Subject: Phase II and III Bond Release of Truck Turnaround Area, PacifiCorp,  
Cottonwood/Wilberg Mine, C/015/0019, Task #6084

## Technical Analysis and Findings

**PID:** C0150019  
**TaskID:** 6084  
**Mine Name:** COTTONWOOD/ WILBERG  
**Title:** PHASE II & III BOND RELEASE TRUCK TURNAROUND

## Inspection Report

**PHOTO 1**  
Cutslopes Turn around

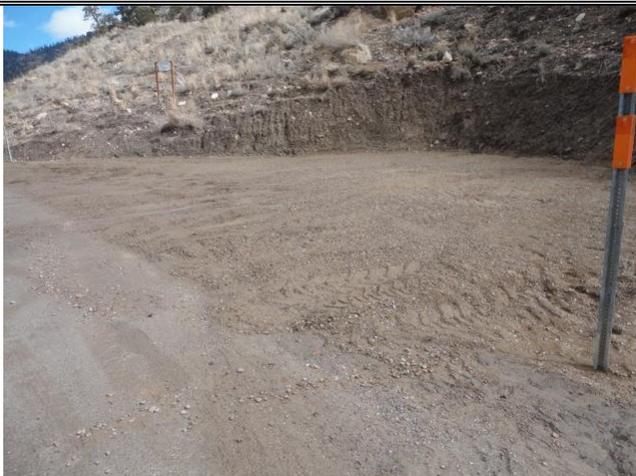
The road base/gravel can be considered as sediment treatment for this 0.080 acres. I did not see any offsite impacts. The turn around was stable. Offsite impacts or evidence of erosion were not observed at the time of the inspection. However, the cutslope could erode during a rainstorm. The cutslope has not been stabilized. See Section 10 for more detail.

The turnaround was developed by removing the material from the hillside. A greater than 2:1 slope was formed with no stabilization measures in place. It is likely that erosion will occur on and above this cutslope after a rainstorm. The area above the cutslope is currently in year 6 of the liability period. Rills will likely form in the Phase I bond released area above the cutslope. If rills are formed in the Phase I area; it is unlikely the permittee will receive Phase II and III bond release. It is recommended that additional action be taken to prevent erosion of the Phase I area above the turnaround or reduce the cutslope angle to 2:1.
